# SUBMITTAL IDENTIFICATION SHEET

WEBSTER UNIVERSITY ISB
PROJECT NAME

055000-017
CONTRACTOR / CM SUBMITTAL NO.

**RE:** HPS Umbilical Trench Shop Drawings

**Image 1** **Image 2**

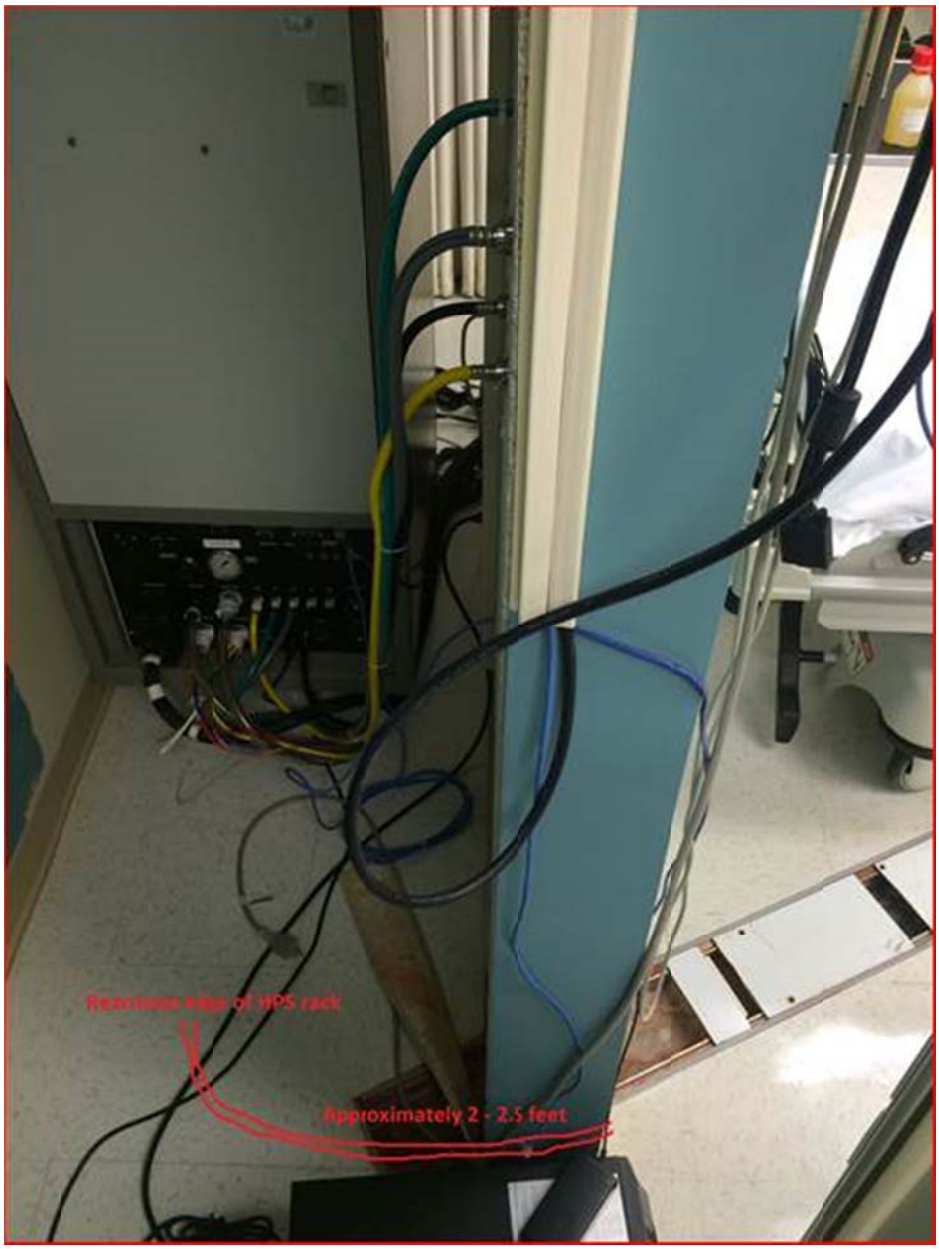
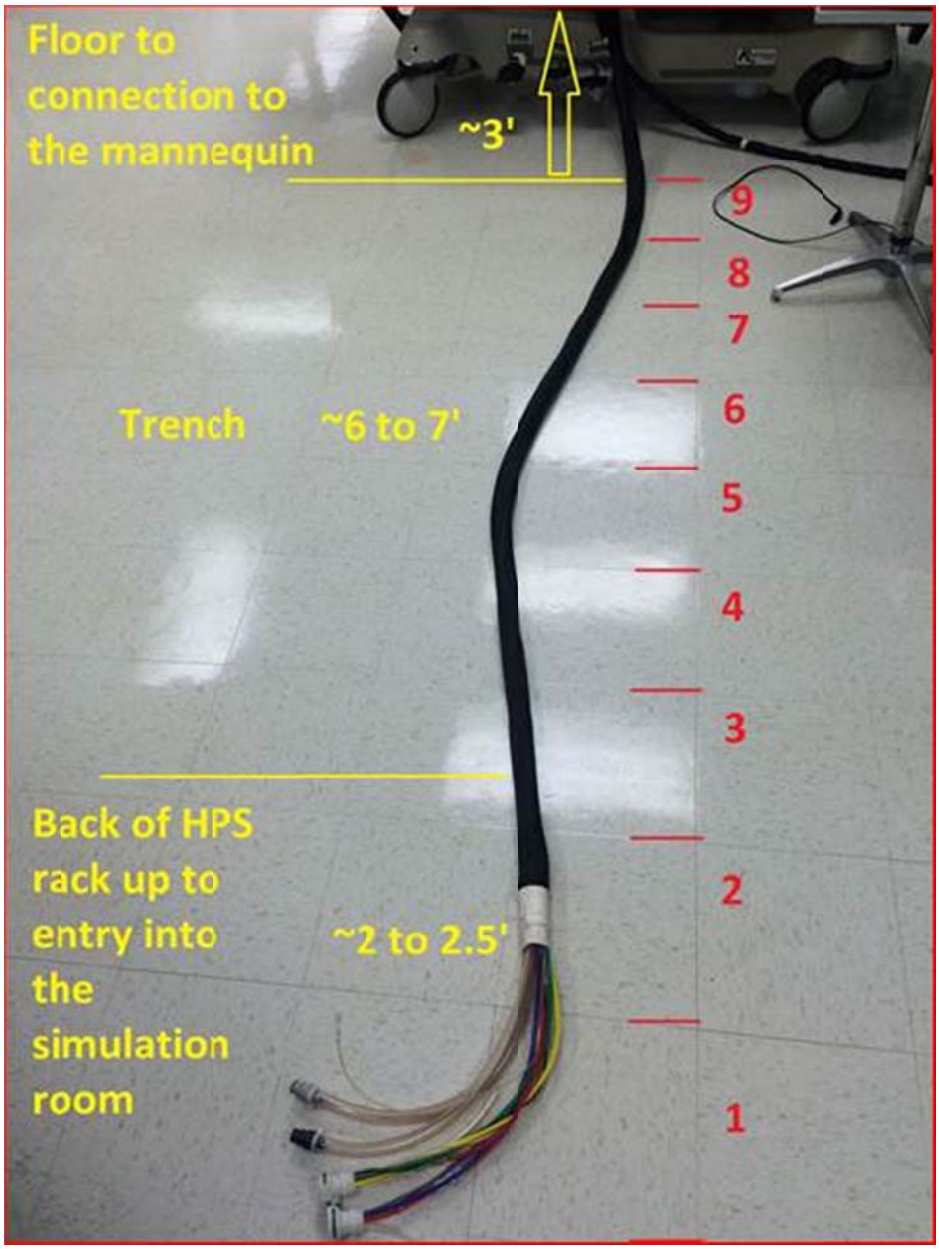
**Recommendation:**
Based on the measurements obtained at C-STARS, the 6 foot measurement for the trench (wall partition to the center line of the OR table, as shown in '*WU-ISB_SIM lab drawings*') is appropriate. The lab drawing shows the trench extending 1' -6 3/8" beyond the center line of the OR table which would allow for flexibility with regards to OR table positioning (height or orientation). The overall trench length of 9 feet is appropriate.

The C-STARS trench cover consisted of steel plates of variable lengths, with each segment 6 inches wide and ¼ inch in thickness. This seemed to work well. I would recommend having the cover divided into segment plates of variable lengths to allow for positioning flexibility (as shown in Images 1 and 2). I would also consider having the plates that are easily removable for ease during repositioning, i.e., not fastened to the trench. (Even though the C-STARS plates could be secured with screws they opted not to secure for ease of removal).

For the exit/entry points of the HPS tubing into the trench, I would certainly consider not securing the trench cover in the event the table is raised or repositioned beyond the available tubing length. With the cover unsecured, it would allow the HPS tubing to lift out of the trench as needed without damage to the tubing.
